Access Compliance Report

Public Rights-of-Way

(Curb Ramps)

Intersection ID: 10844	Main Street: W_5TH_ST	Cross Street: FRAZIER_AV	Location: N
ADA ID: EC583087478F	Ramp Type: PerpDiag	Initial Pass/Fail: Fail	Overall Compliance: No
Severity Score: 17.5			
Codes/Mitigation Info/Possible Solution		Field Measurements/Component Compliance

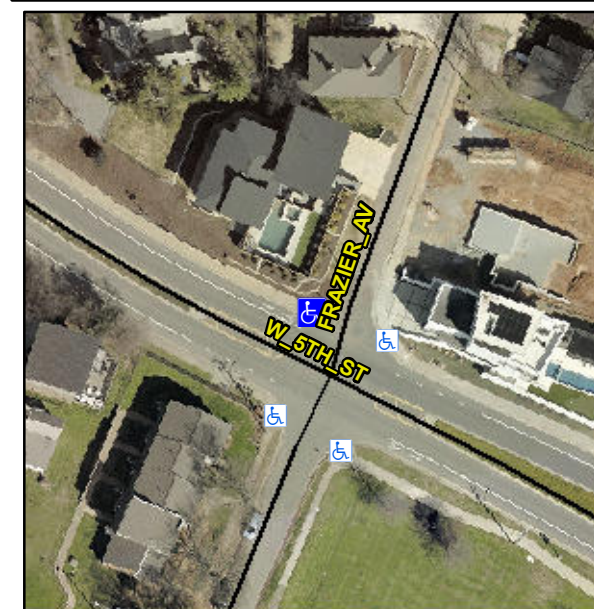
Not Found, R304.5.1

Compliance	Description	Data	Compliance	Description	Data
N/A	Ramp Length (in)	61.5	Yes	Ramp Slope (%)	8.1
No	Ramp Width (in)	33.0	Yes	Ramp XSlope (%)	0.3
N/A	Flare Type LT	N/A	N/A	Flare Type RT	N/A
N/A	Flare Slope LT (%)	N/A	N/A	Flare Slope RT (%)	N/A
N/A	Flare Traversable LT?	N/A	N/A	Flare Traversable RT?	N/A
N/A	Landing Length (in)	N/A	N/A	DWS Provided?	N/A
N/A	Landing Width (in)	N/A	N/A	DWS Contrast?	N/A
N/A	Landing Slope (%)	N/A	N/A	DWS Length (in)	N/A
N/A	Landing X Slope (%)	N/A	N/A	DWS Full Width?	N/A
N/A	Landing Curb? (Y/N)	N/A	N/A	DWS Offset (in)	N/A
N/A	Shared Landing?	N/A			
N/A	Gutter Ponding?	N/A	N/A	Gutter Slope (%)	N/A
N/A	Gutter Lip Ht (in)	N/A	N/A	Gutter X Slope (%)	N/A
N/A	Painted X Walk1?	No	N/A	Painted X Walk2?	No
	X Walk 1 Direction	To SW		X Walk 2 Direction	To SE
N/A	X Walk 1 Width (in)	N/A	N/A	X Walk 2 Width (in)	N/A
	X Walk 1 Slope (%)	2.4		X Walk 2 Slope (%)	8.1
	X Walk 1 X Slope (%)	5.0		X Walk 2 X Slope (%)	3.5

N/A	Ramp inside XWalk1?	N/A	N/A	Ramp inside XWalk2?	N/A
	Road Slope (%)	0.2	N/A	Clear Space?	N/A
	Road X Slope (%)	7.6	N/A	Clear Space to XWalk (in)	N/A
N/A	Any Obstructions?	N/A	N/A	Storm Grate/Utility Hazard?	N/A
	Obstruction Type			Storm Grate/Utility Type	
		N/A			N/A
		Yes		Surface Condition? (G/P)	Good

Remove & Replace Curb Ramp With Two New Directional Ramps or Equivalent.
